# SAN FRANCISCO PLANNING DEPARTMENT

## DRAFT Planning Commission Motion NO. M-XXXXX

*Hearing Date:* August 24, 2017  
*Case No.:* **2014-001272ENV**  
*Project Title:* **Pier 70 Mixed-Use District Project**  
*Zoning:* M-2 (Heavy Industrial) and P (Public)  
40-X and 65-X Height and Bulk Districts  
*Block/Lot:* Assessor's Block 4052/Lot 001, Block 4111/Lot 004  
Block 4120/Lot 002, and Block 4110/Lots 001 and 008A  
*Project Sponsor:* David Beaupre/Port of San Francisco  
[david.beaupre@sport.com](mailto:david.beaupre@sport.com), (415) 274-0539  
Kelly Pretzer/Forest City Development California, Inc.  
[KellyPretzer@forestcity.net](mailto:KellyPretzer@forestcity.net), (415) 593-4227  
*Staff Contact:* Melinda Hue – (415) 575-9041  
[melinda.hue@sfgov.org](mailto:melinda.hue@sfgov.org)

### ADOPTING FINDINGS RELATED TO THE CERTIFICATION OF A FINAL ENVIRONMENTAL IMPACT REPORT FOR THE PROPOSED PIER 70 MIXED-USE DISTRICT PROJECT.

(NEW) FIGURE 6.1: IRISH HILL PASSAGWAY VARIANT

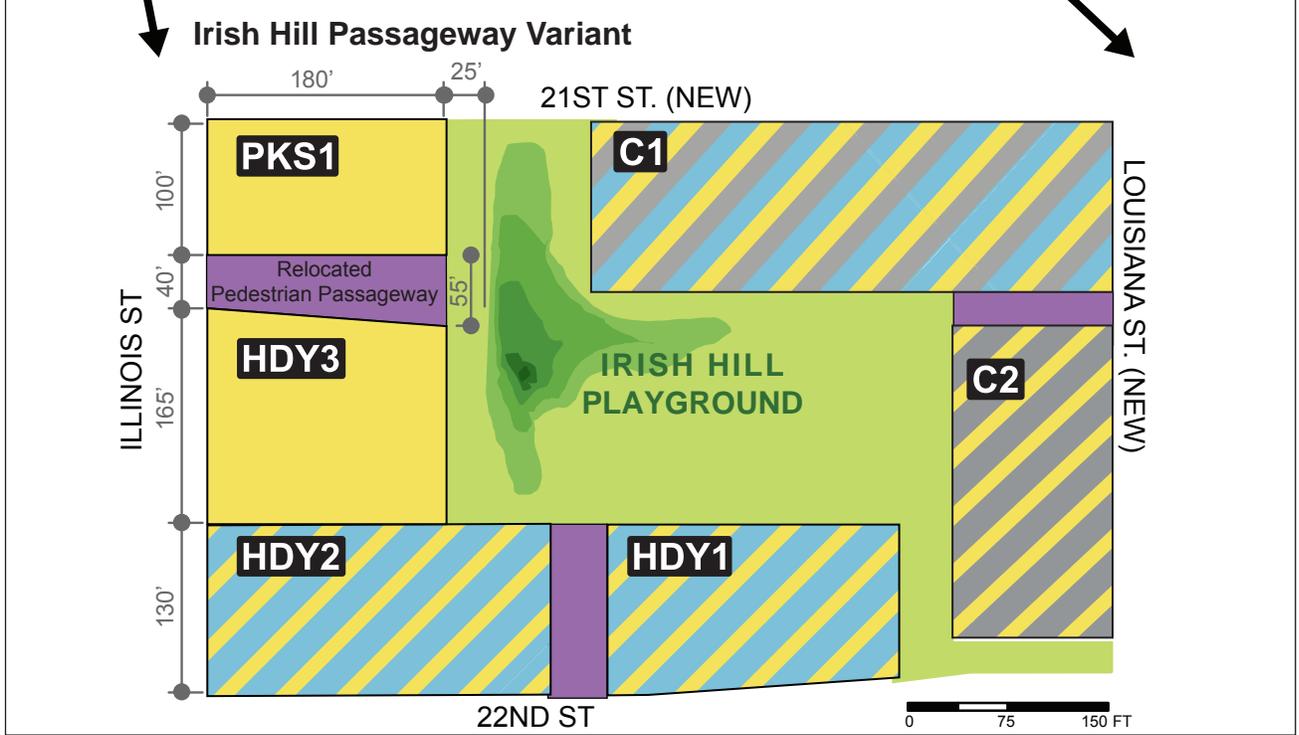
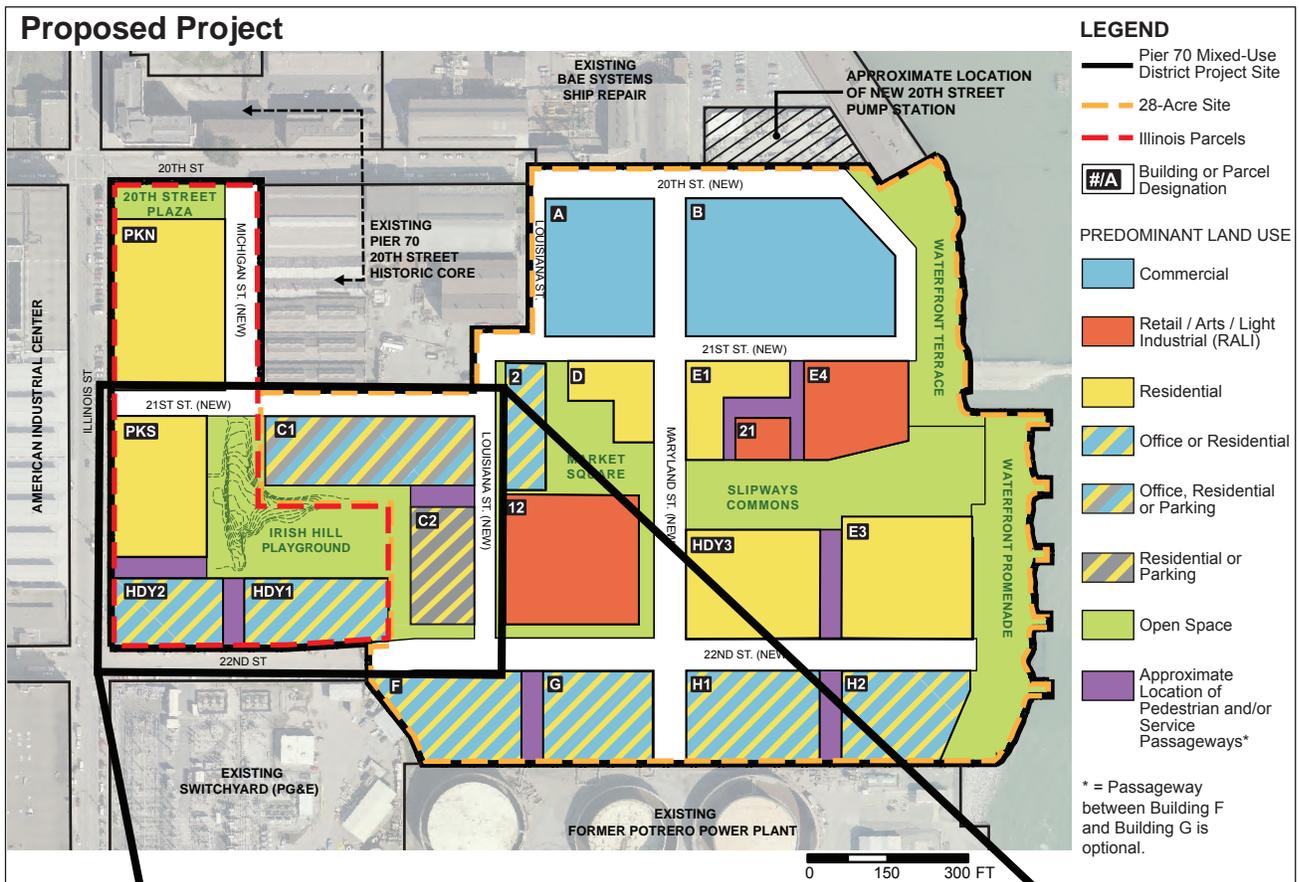
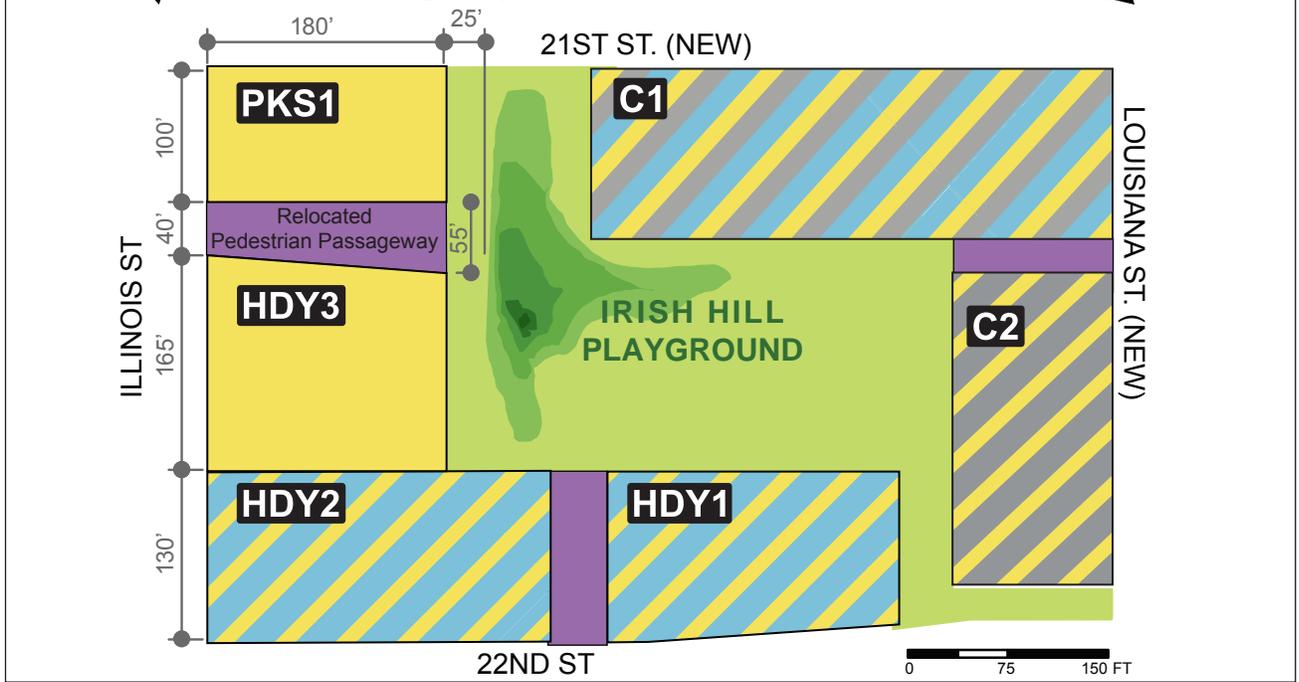
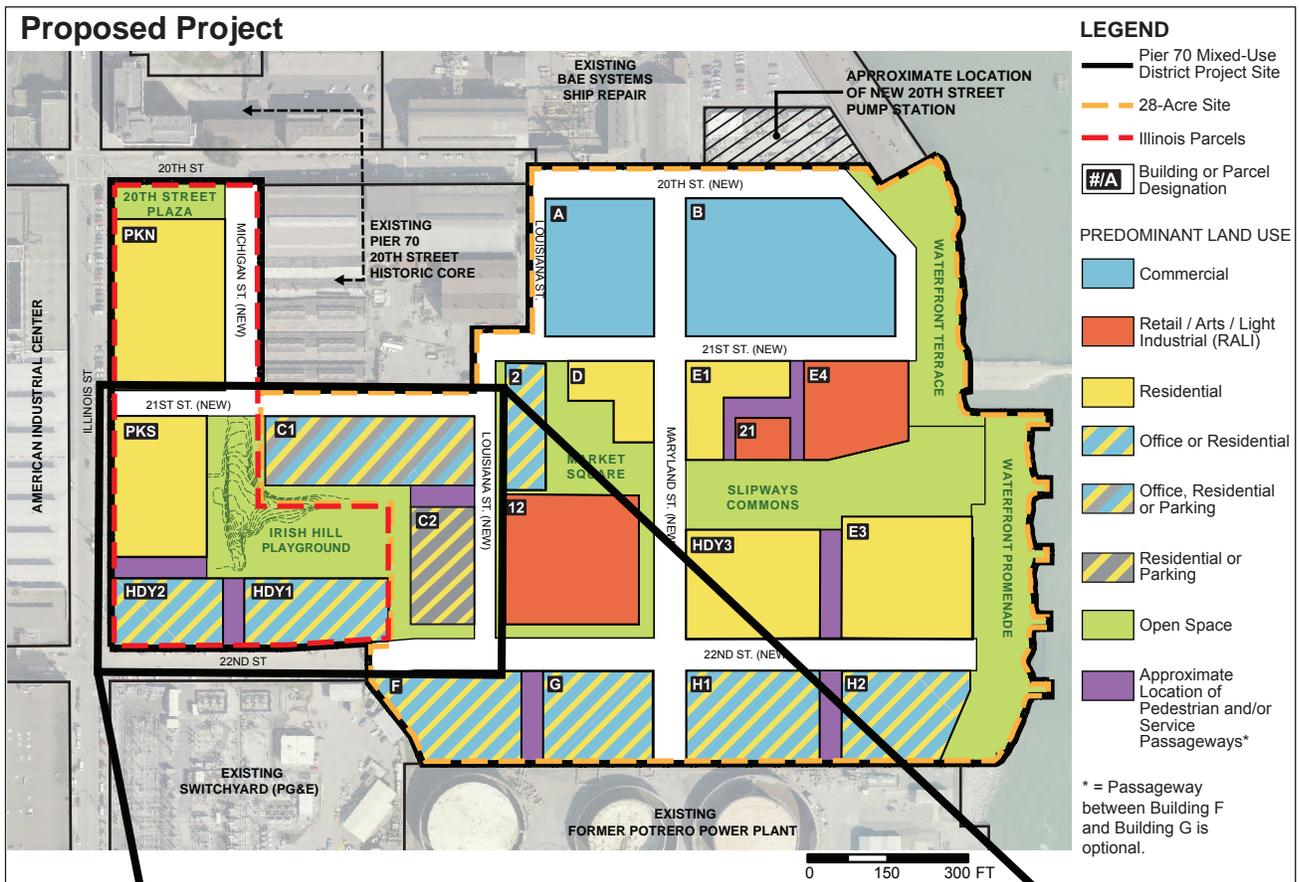
Under the Irish Hill Passageway Variant, the pedestrian passageway would be shifted northward by approximately 165 feet, bisecting Parcel PKS(which would become PKS1 and HDY3 with this variant), and would widen from 40 feet at Illinois Street to 55 feet at Irish Hill Playground, to allow views of the western face of the Irish Hill remnant from Illinois Street. (See Figure 6.1: The Irish Hill Passageway Variant.)

Under the Irish Hill Passageway Variant, the pedestrian passageway would be shifted northward by approximately 165 feet, bisecting Parcel PKS (which would become PKS1 and HDY3 with this variant), and would widen from 40 feet at Illinois Street to 55 feet at Irish Hill Playground, to allow views of the western face of the Irish Hill remnant from Illinois Street. (See Figure 6.1: The Irish Hill Passageway Variant.)

(NEW) FIGURE 6.2: PROPOSED PROJECT SHADOW ON IRISH HILL PLAYGROUND AT 4:00 PM (PDT) ON THE SUMMER SOLSTICE

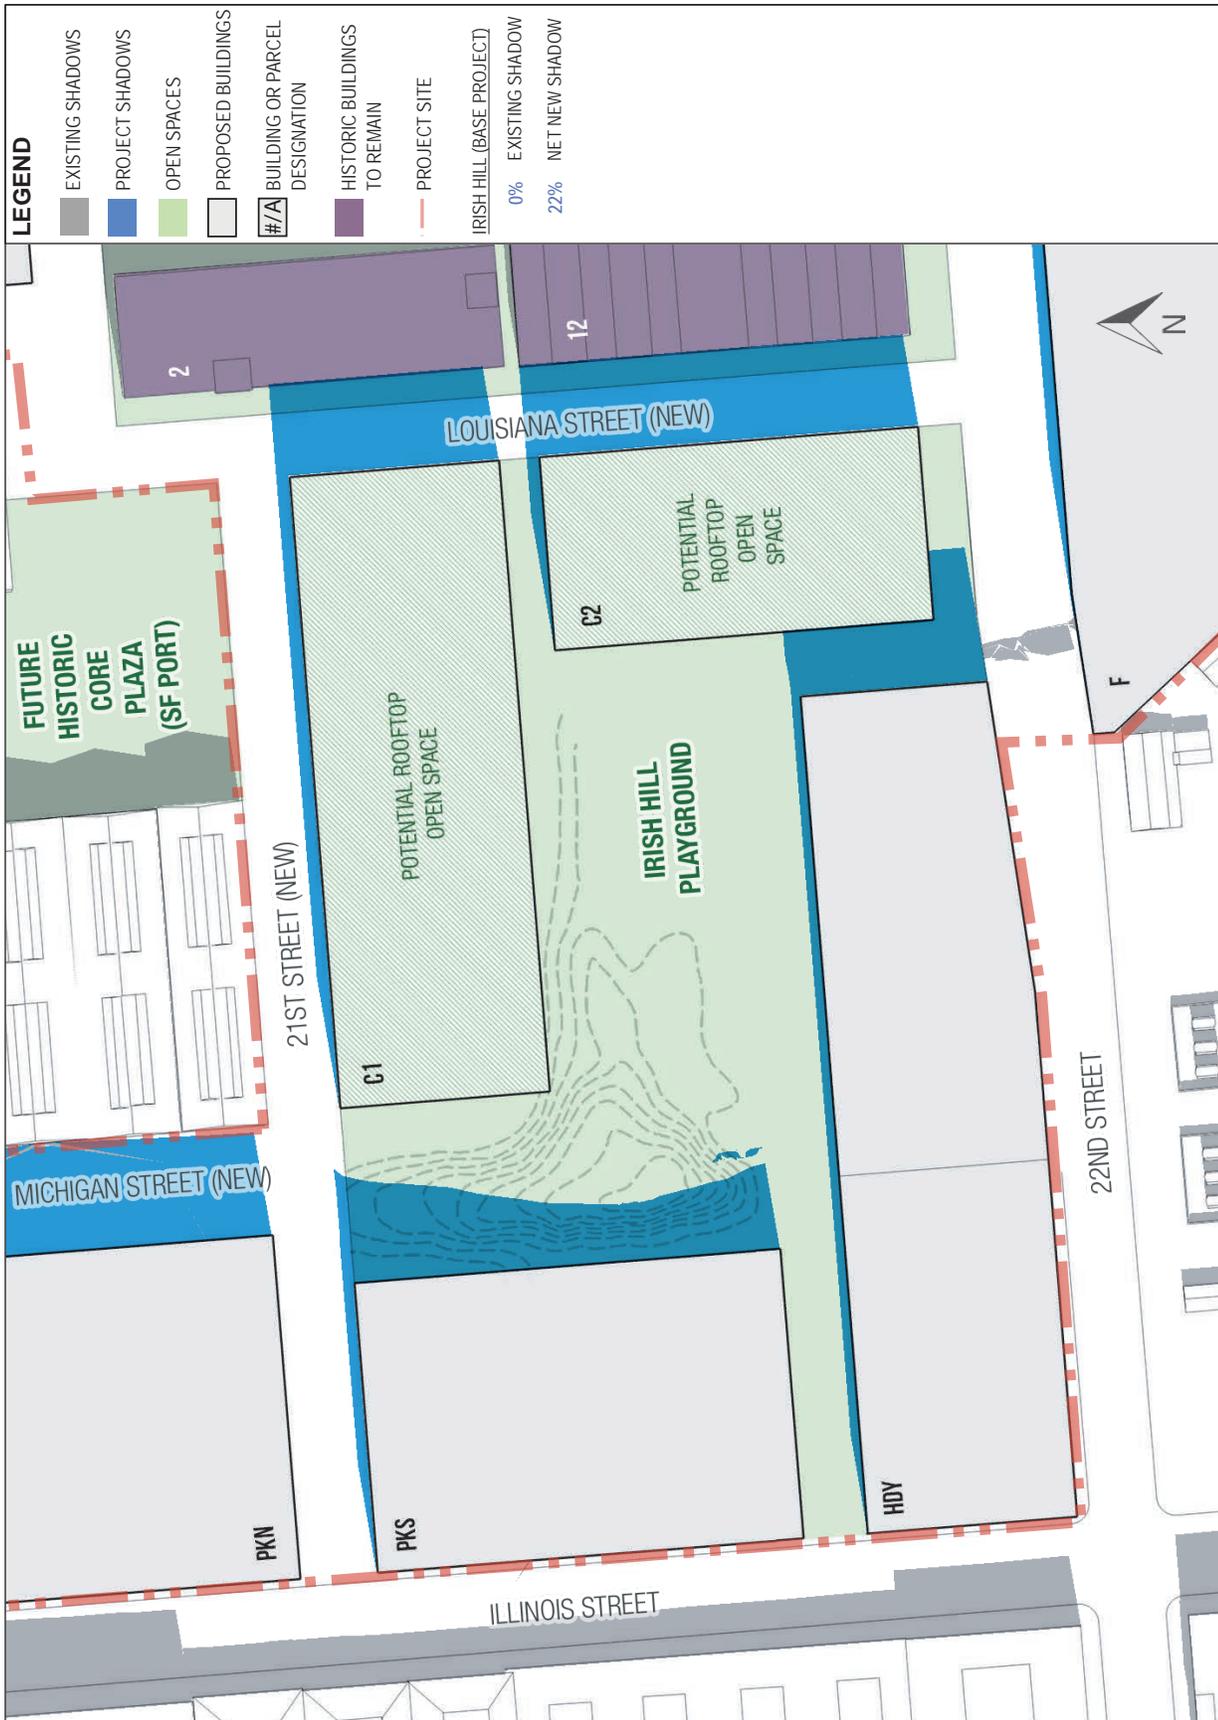
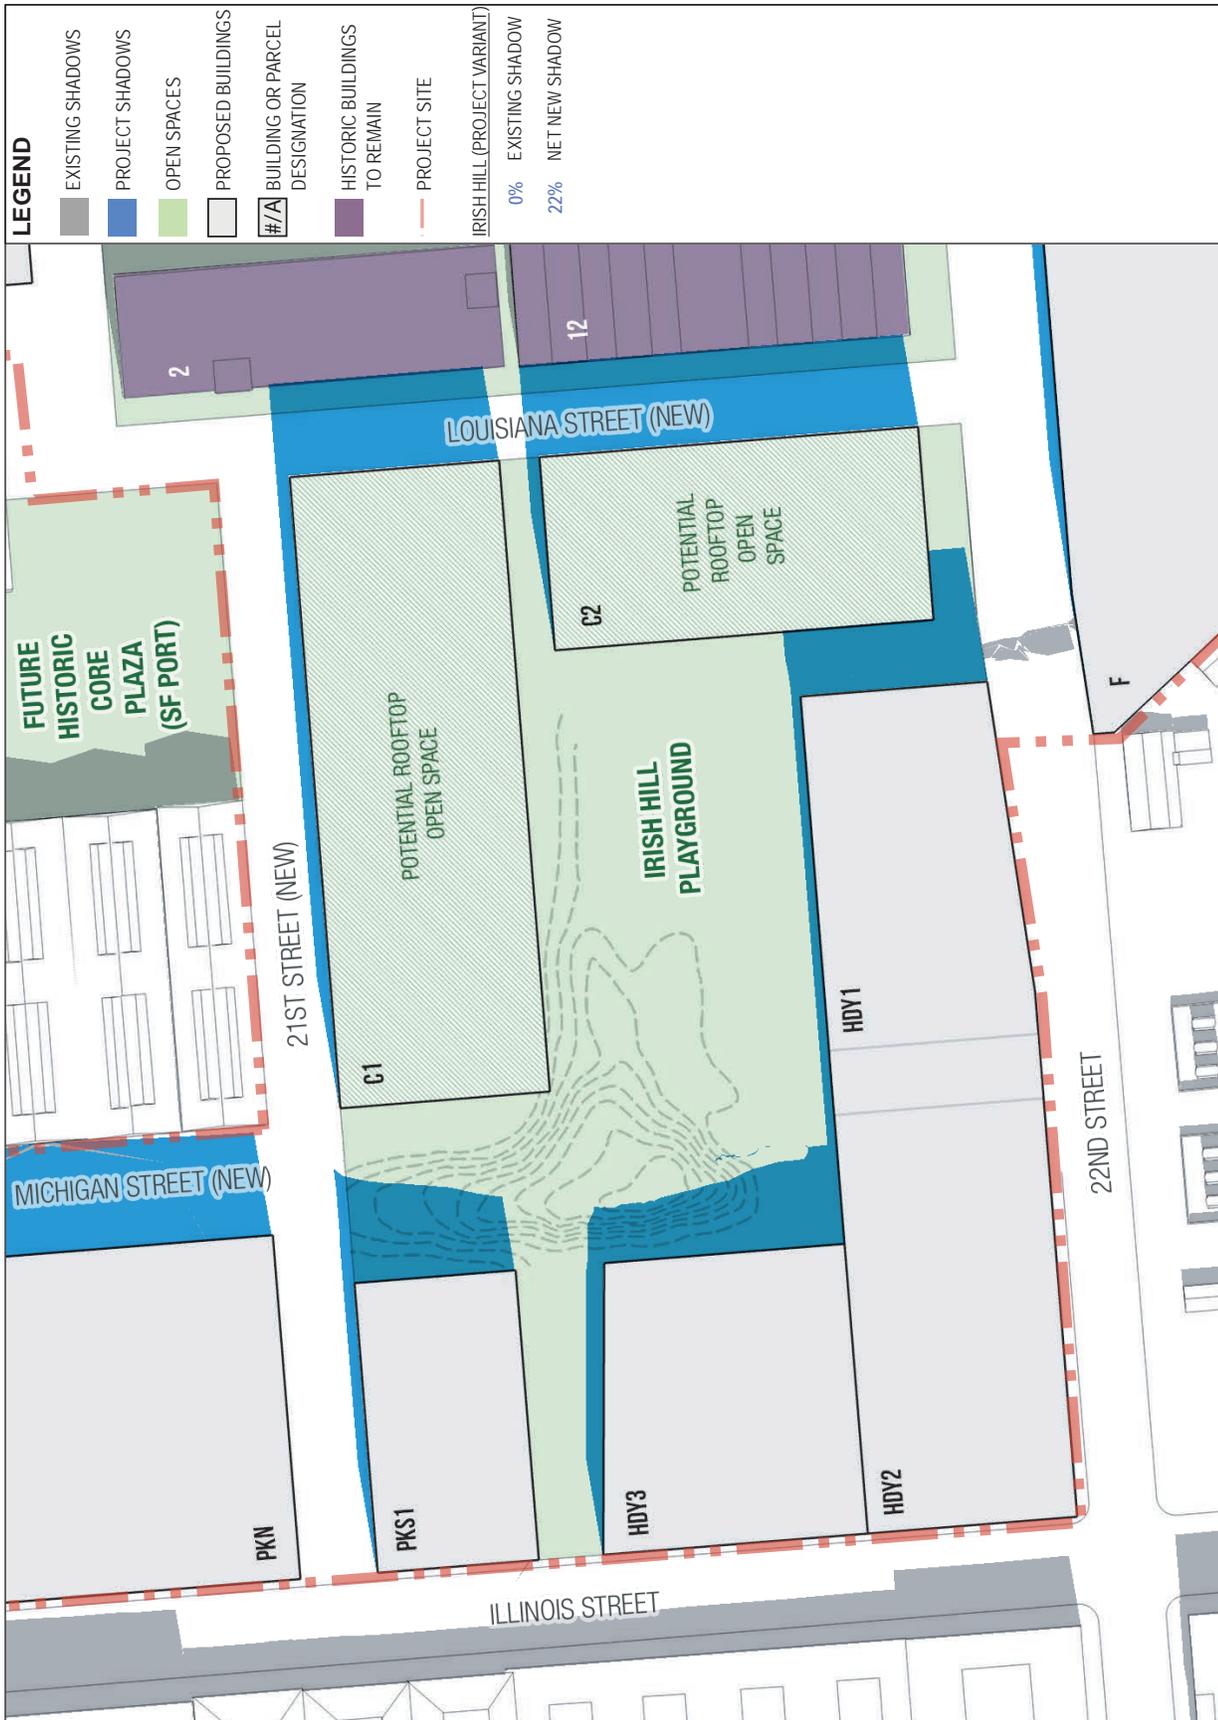
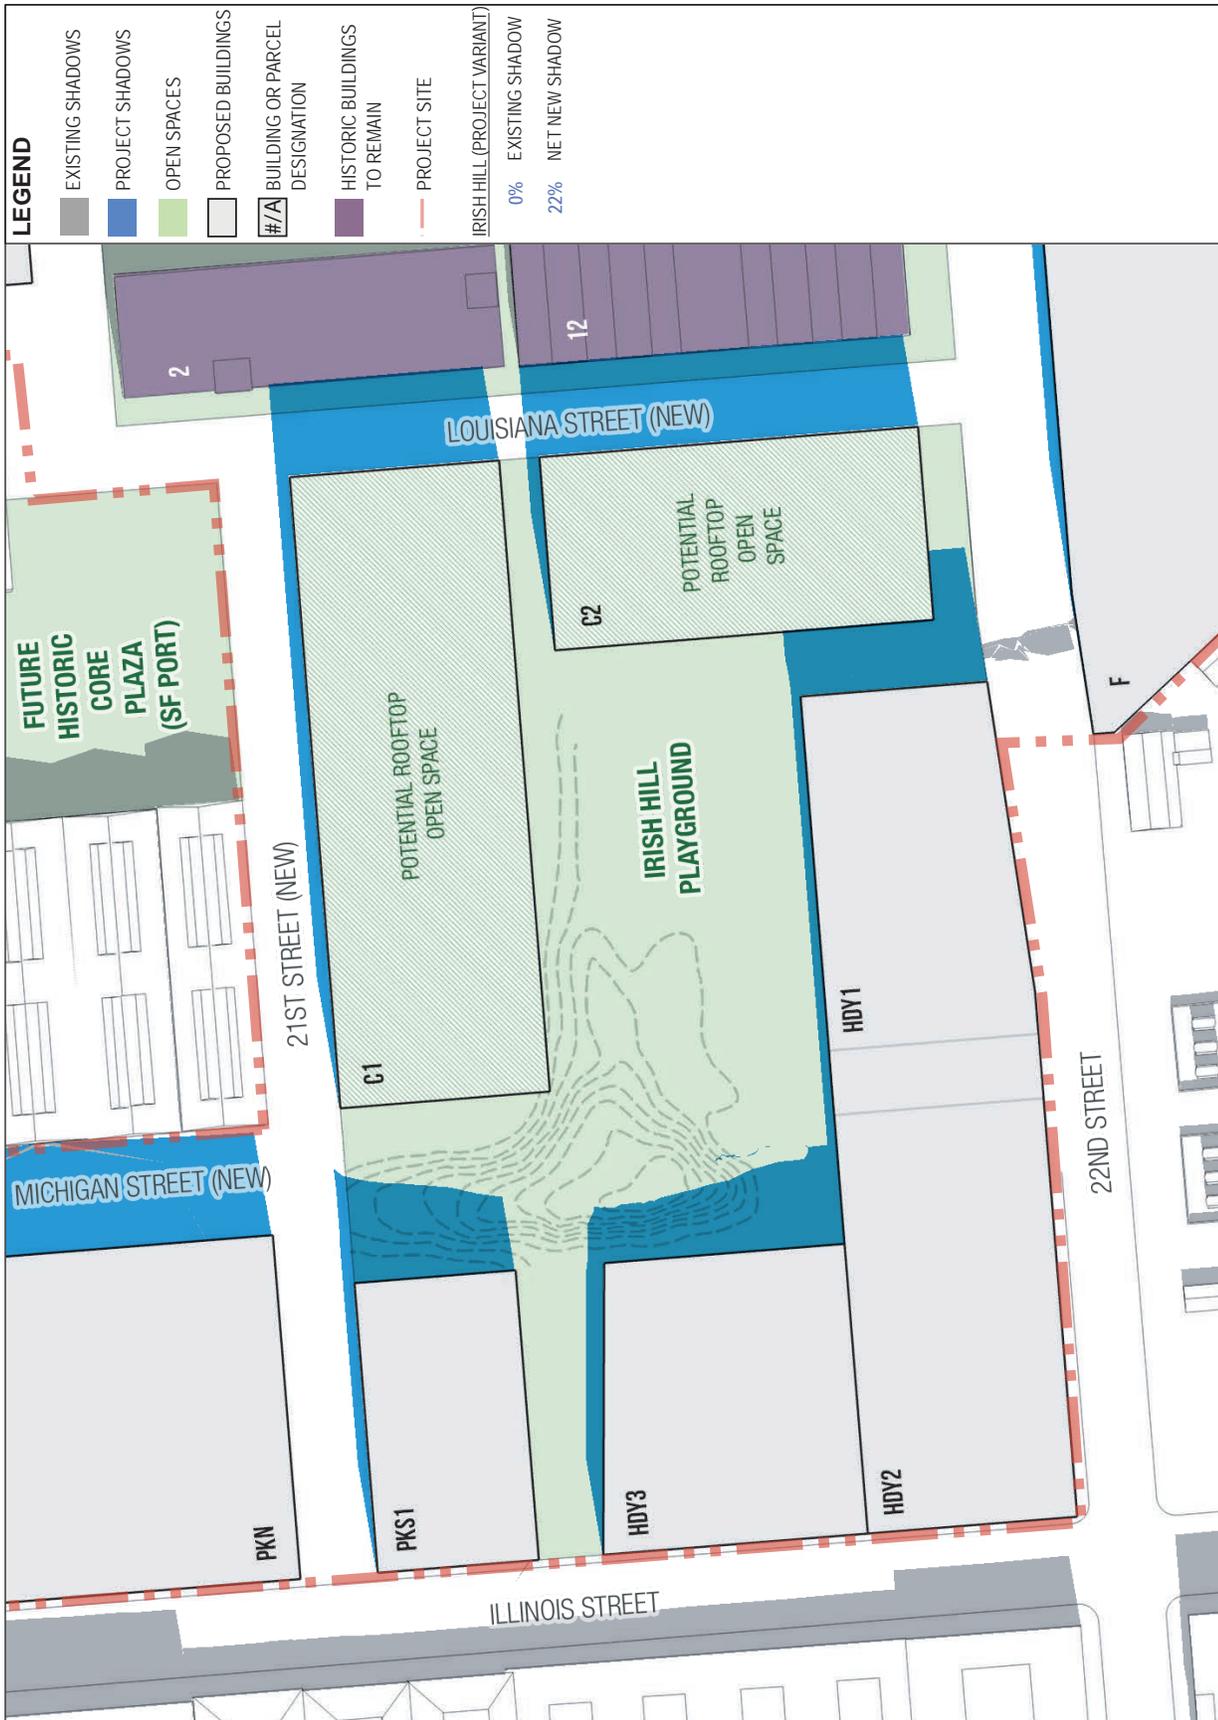
See Figure 6.2: Proposed Project Shadow on Irish Hill Playground at 4:00 PM (PDT) on the Summer Solstice. This figure shows the pedestrian passageway at the southern end of Parcel PKS in sunlight (the passageways are considered part of the open space). At this time of year and day, the sun aligns with the east-west orientation of the pedestrian passageway in the late afternoon. Figure 6.3: Irish Hill Passageway Variant Shadow on Irish Hill Playground at 4:00 PM (PDT) on the Summer Solstice shows the sunlit passageway shifted to the north. As the day progresses, the variant shadow on Irish Hill Playground, like the Proposed Project, would lengthen and sweep eastward and southward.

See Figure 6.2: Proposed Project Shadow on Irish Hill Playground at 4:00 PM (PDT) on the Summer Solstice. This figure shows the pedestrian passageway at the southern end of Parcel PKS in sunlight (the passageways are considered part of the open space). At this time of year and day, the sun aligns with the east-west orientation of the pedestrian passageway in the late afternoon. Figure 6.3: Irish Hill Passageway Variant Shadow on Irish Hill Playground at 4:00 PM (PDT) on the Summer Solstice shows the sunlit passageway shifted to the north. As the day progresses, the variant shadow on Irish Hill Playground, like the Proposed Project, would lengthen and sweep eastward and southward.
